Final Environmental Impact Statement for the Mineral Resource Management Plan

Potential Exploration, Development,
and Production of Oil and Gas Resources

Vandenberg Air Force Base

FINAL ENVIRONMENTAL IMPACT STATEMENT

Figure 3.2-1A
WATER WELL LOCATIONS

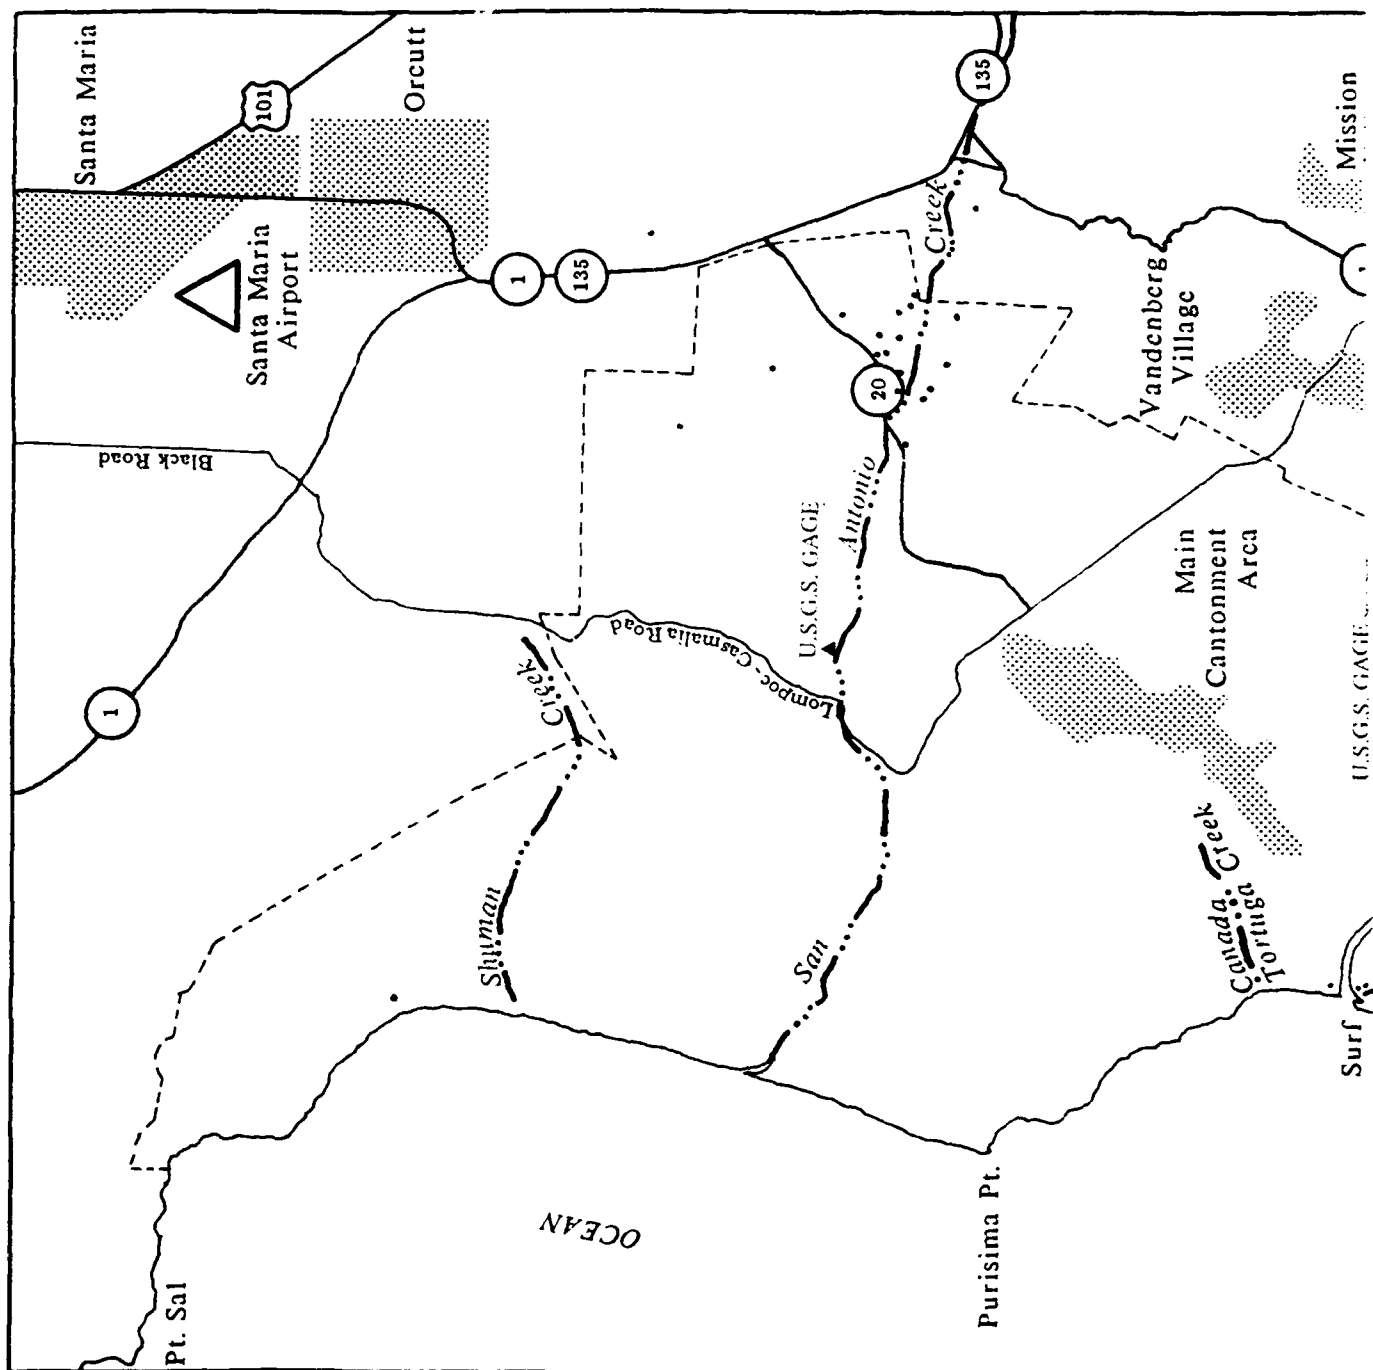
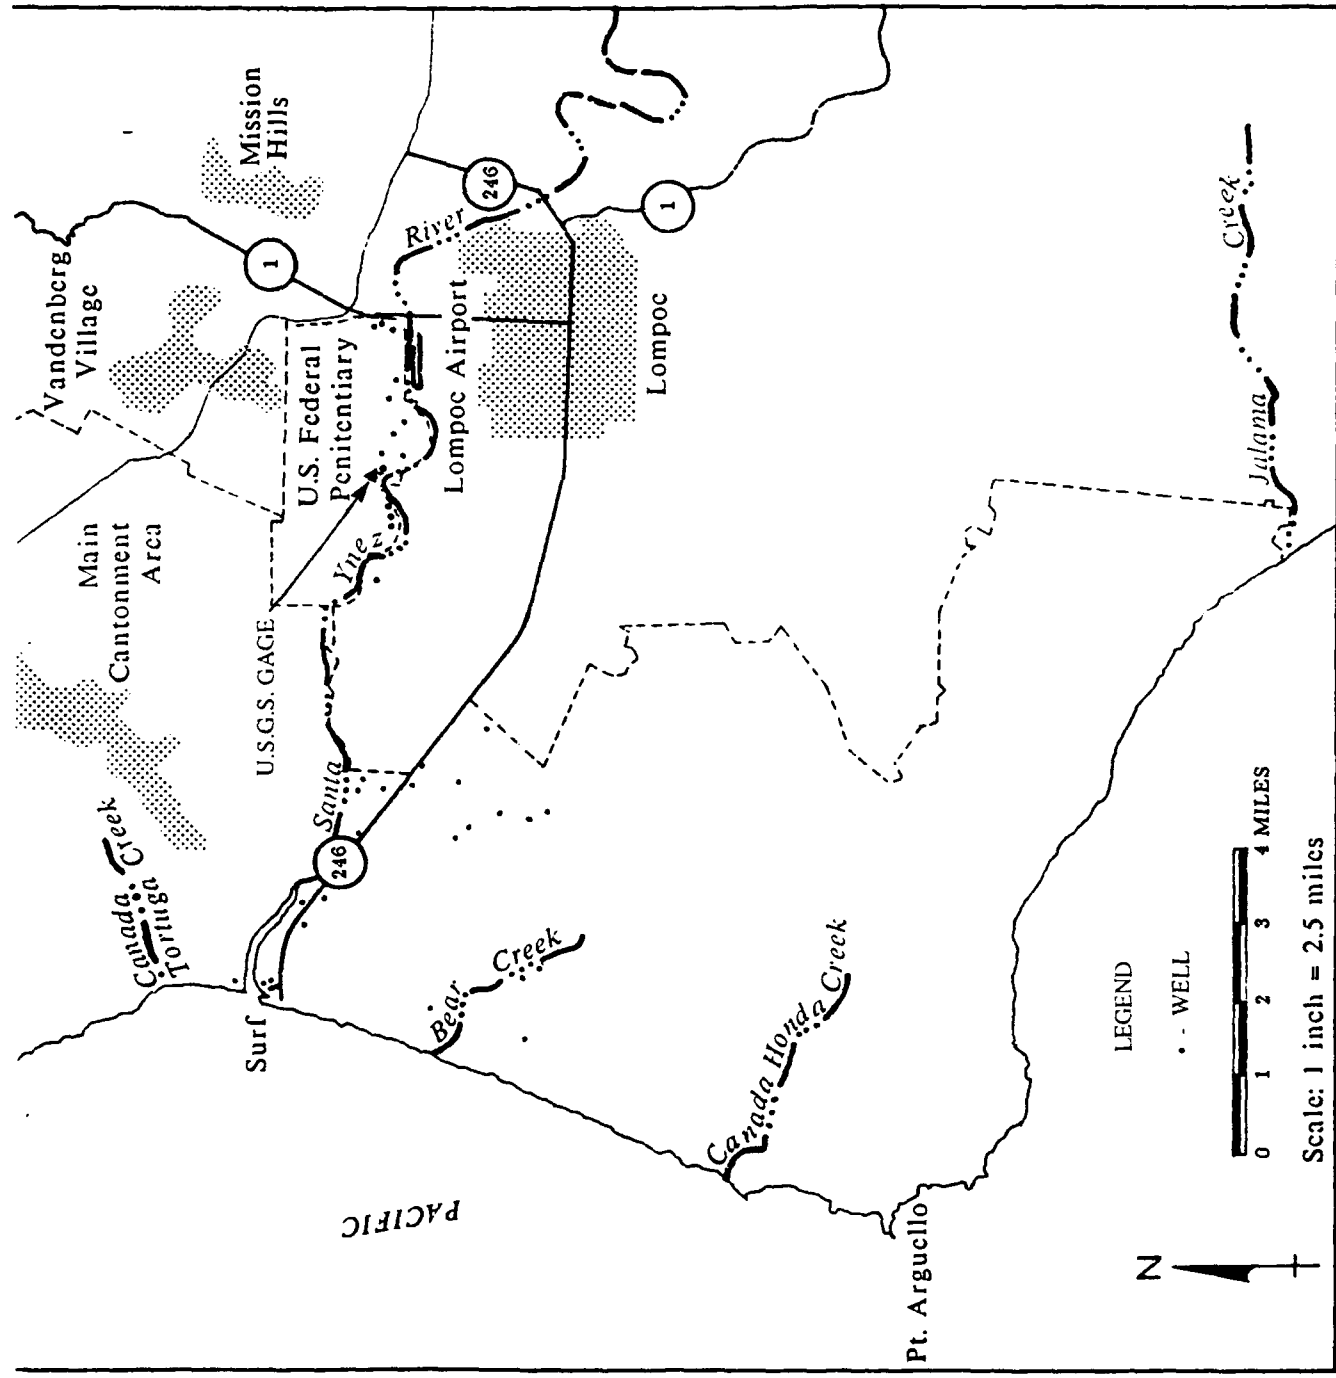
Section 3.2.4.1.2; page 3.2-8, add the following sentence at the end of paragraph one: "Water well locations are shown in Figure 3.2-1A." See the attached figure.

Figure 3.3-2
SANTA BARBARA COUNTY AIR QUALITY
MANAGEMENT REGION

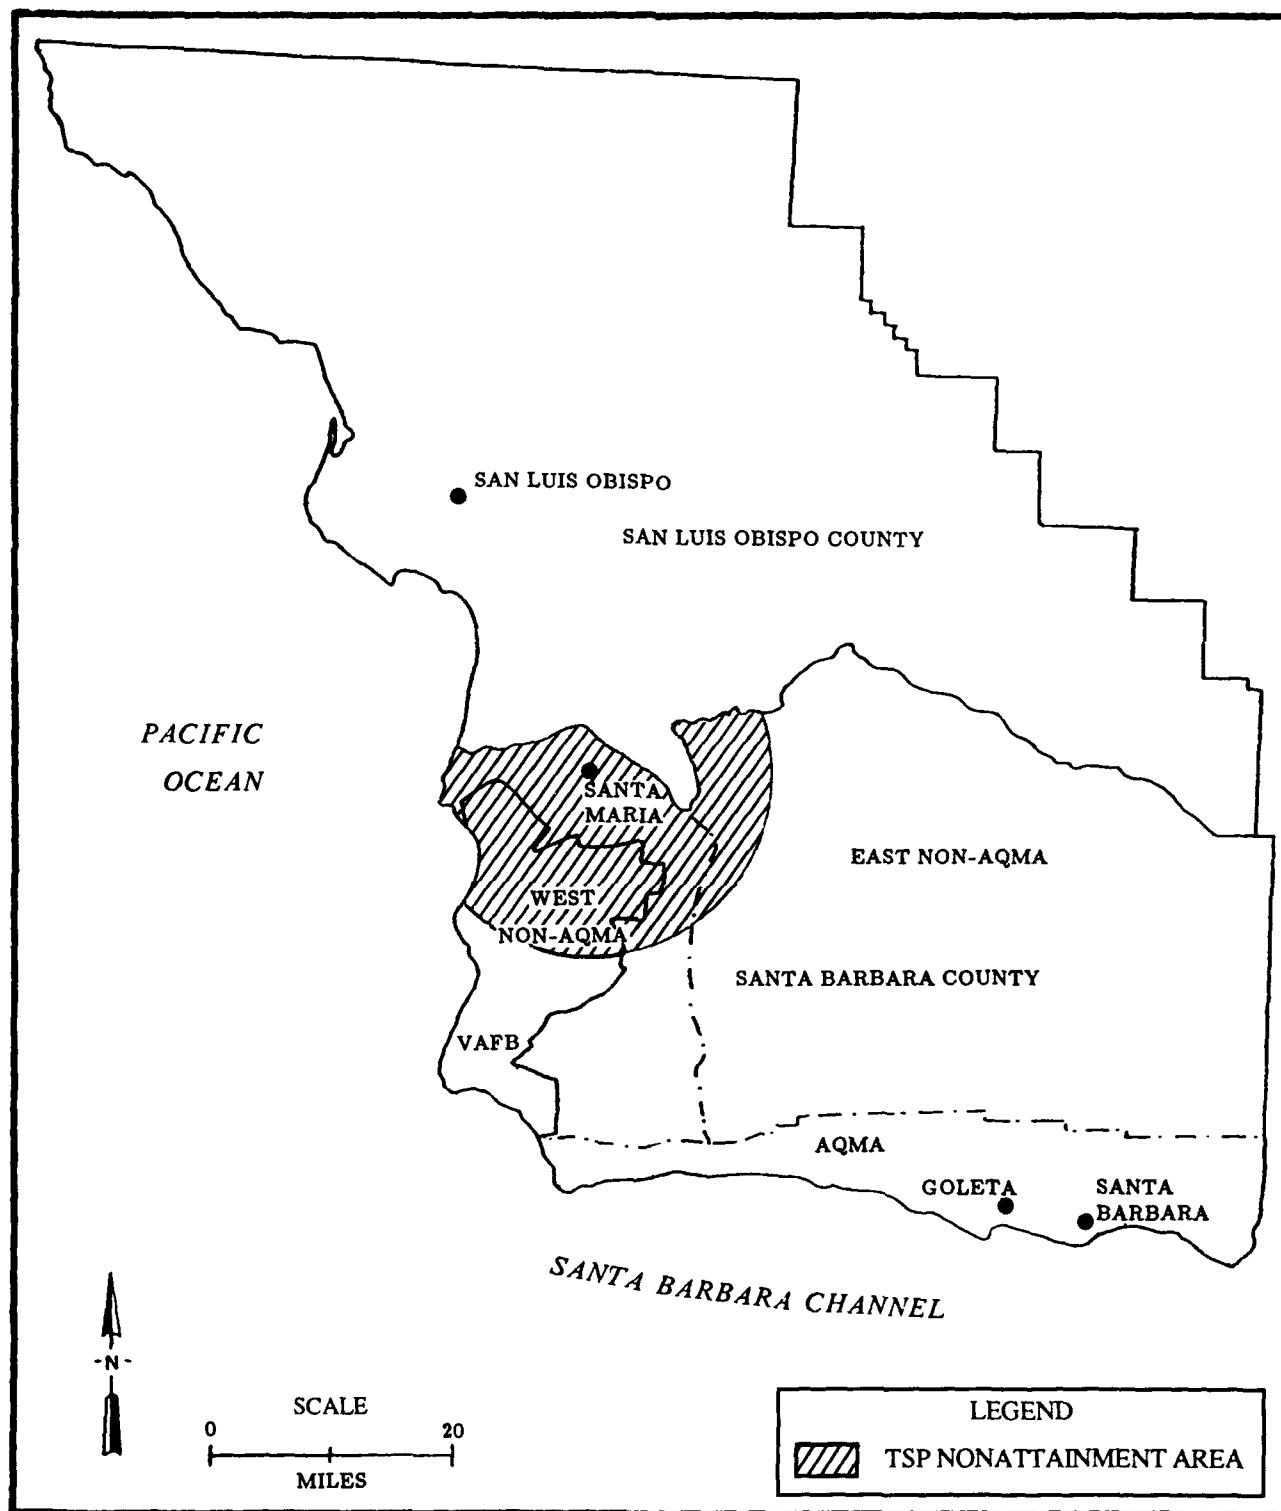
Page 3.3-9, the TSP nonattainment area in Figure 3.3-2 has been corrected to only include the 15-mile radius from Santa Maria that is within Santa Barbara County.

1. The TSP non-attainment area described on page 3.3-7 and depicted in Figure 3.3-2 mistakenly includes a portion of southern San Luis Obispo County. No areas in San Luis Obispo County are currently designated as Federal non-attainment areas for any pollutants. TSP measurements at Nipomo are well within Federal standards. The Nipomo monitoring station is located approximately nine miles north of Santa Maria. This correction should be noted in the FEIS.

Figure 3.3-3
AIR QUALITY MONITORING STATIONS

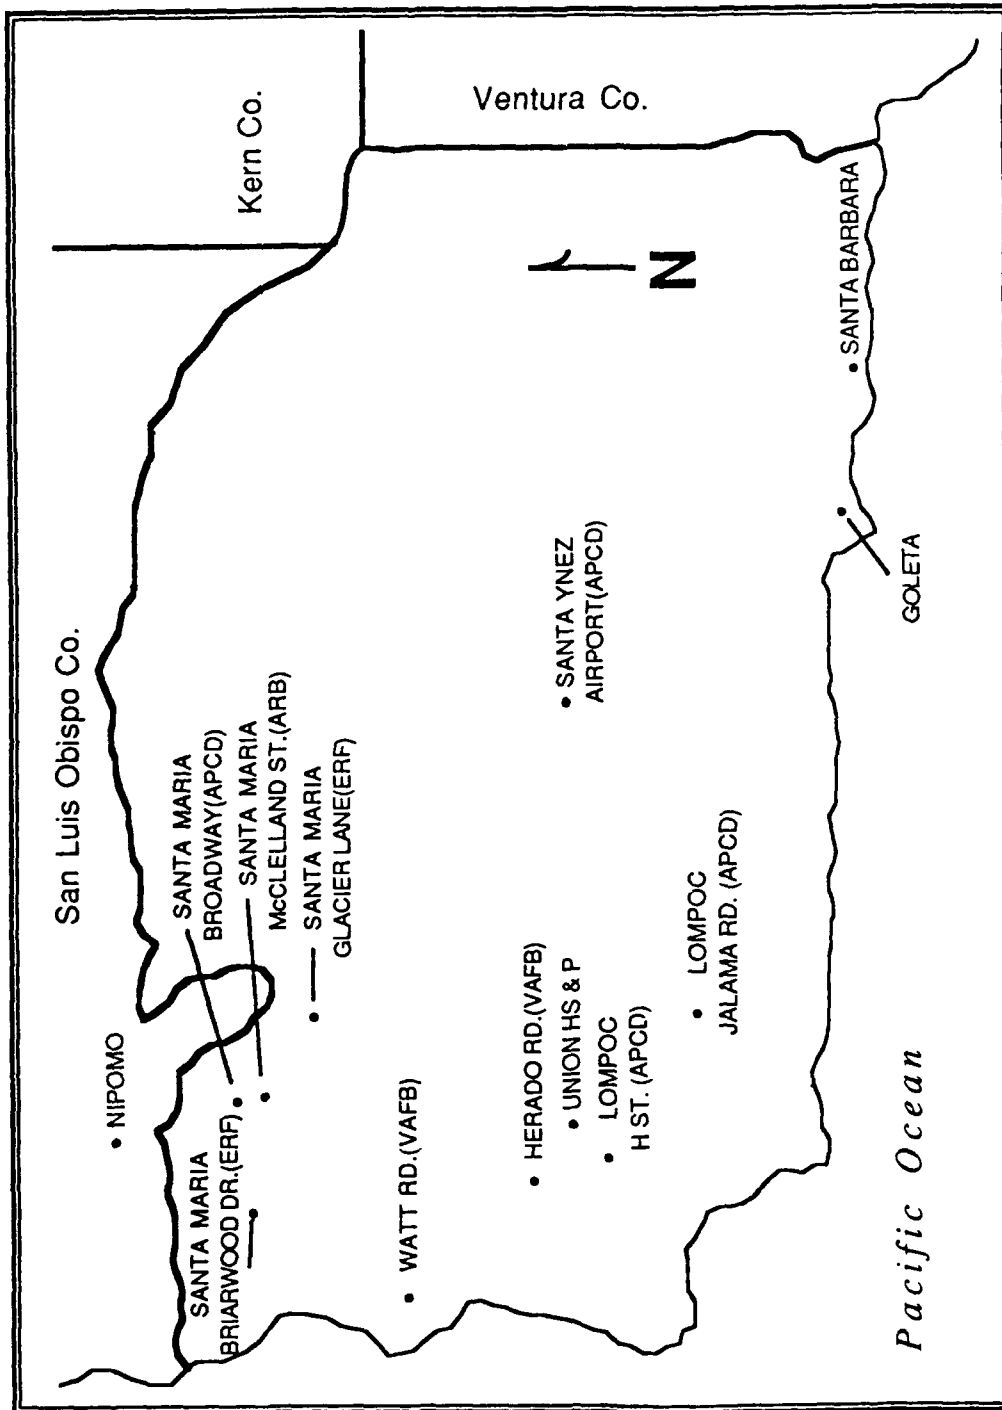
Page 3.3-11, Figure 3.3-3 has been changed to include the Nipomo monitoring station in San Luis Obispo County. See the attached figure.

Figure 3.8-1
PRINCIPAL TRANSPORTATION ACCESS TO VAFB

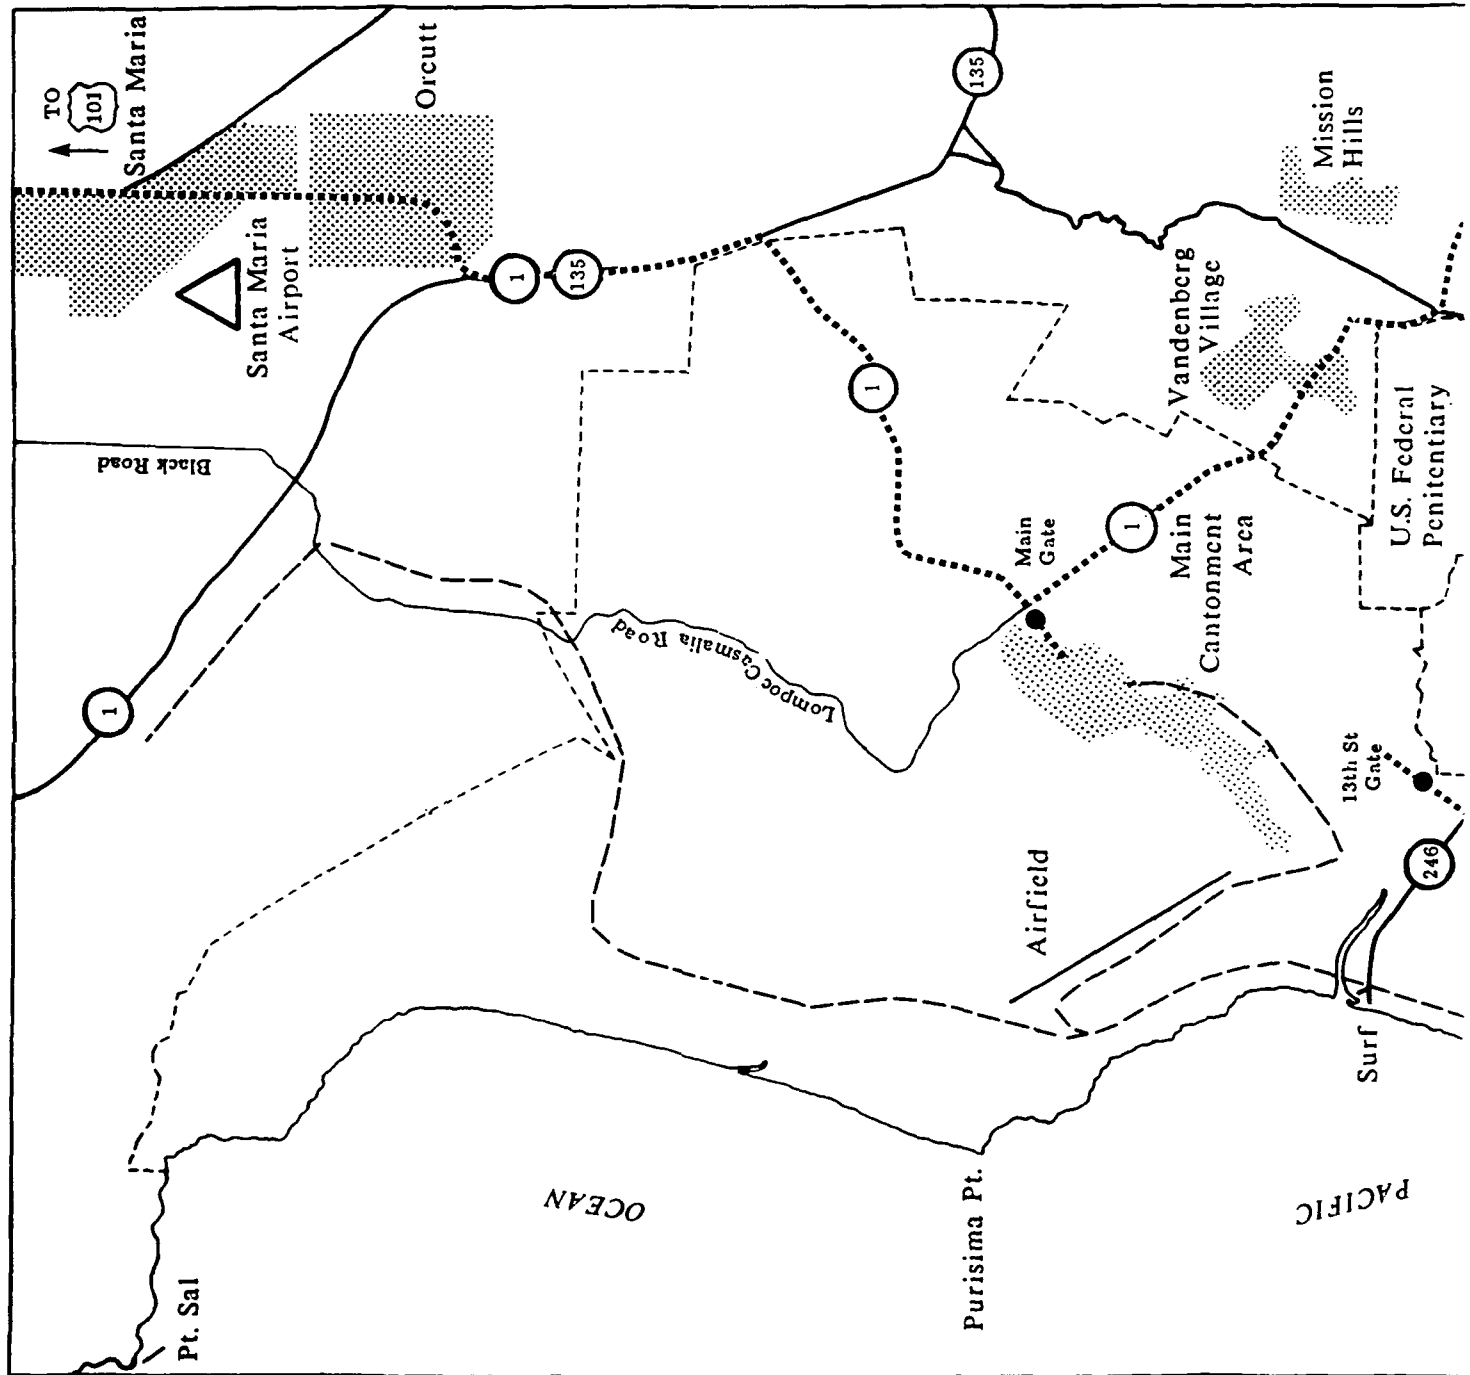
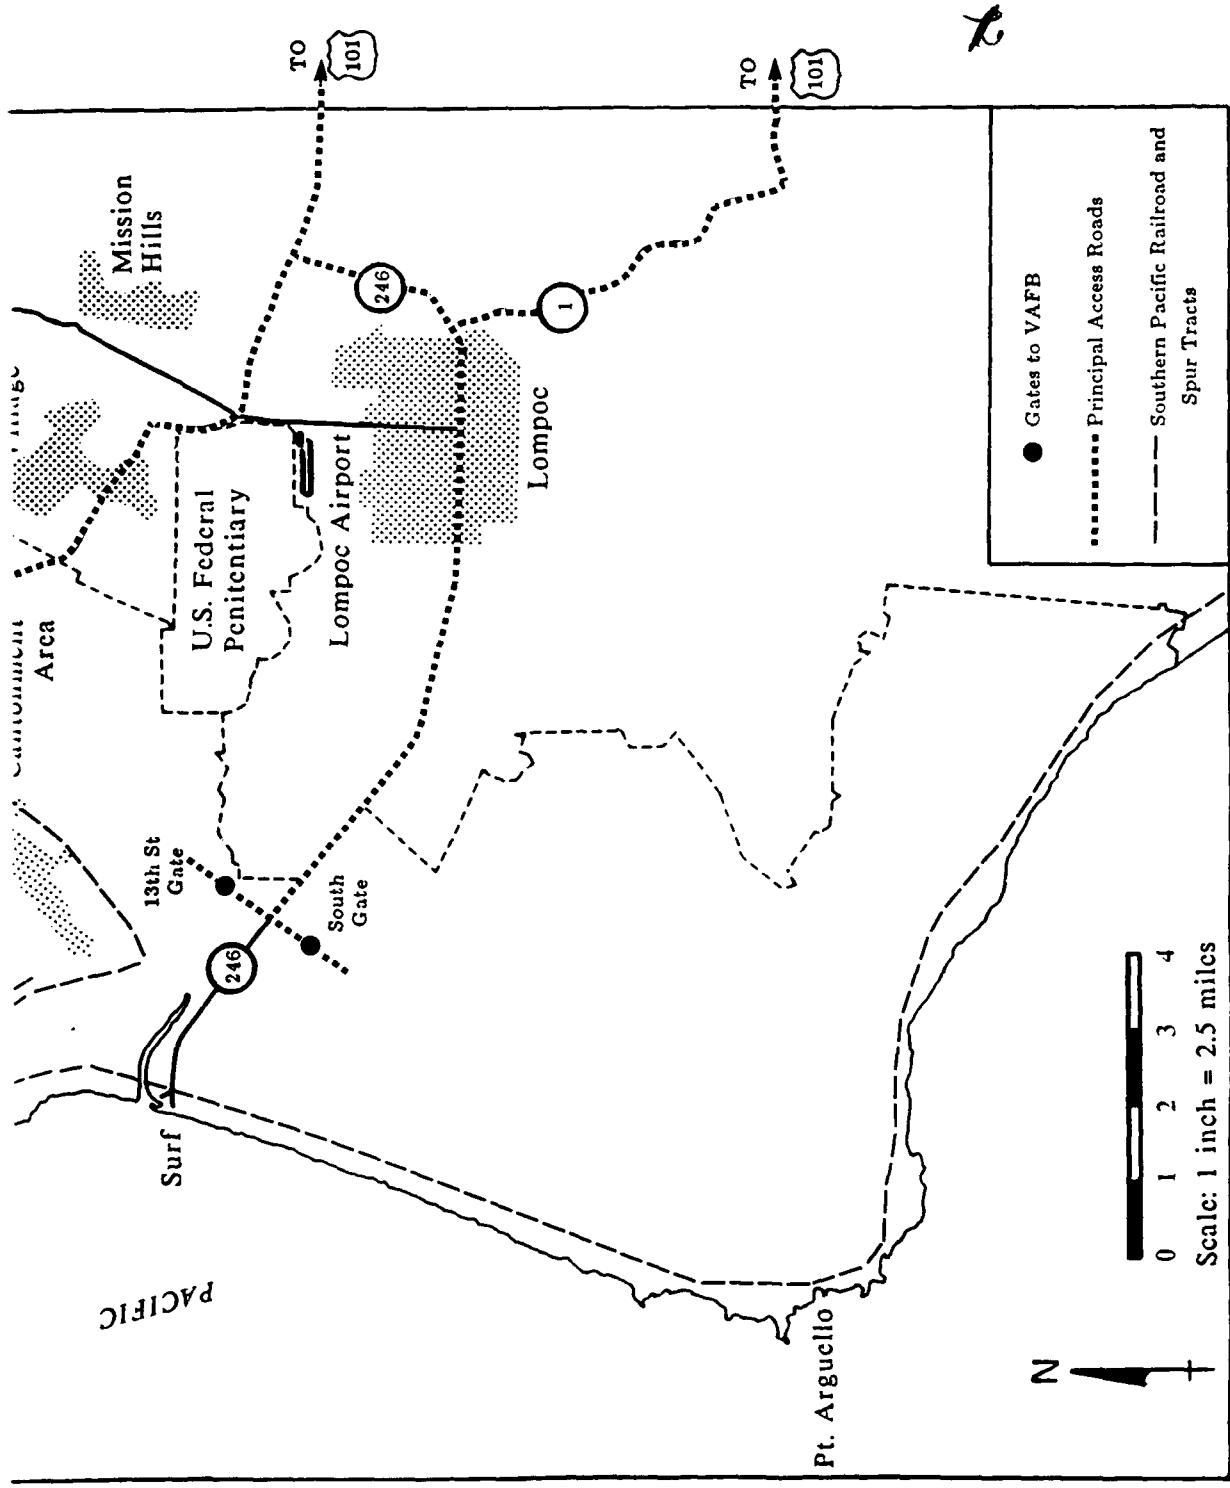
Figure 3.8-1 on page 3.8-3 has been revised. Please see the attached figure.
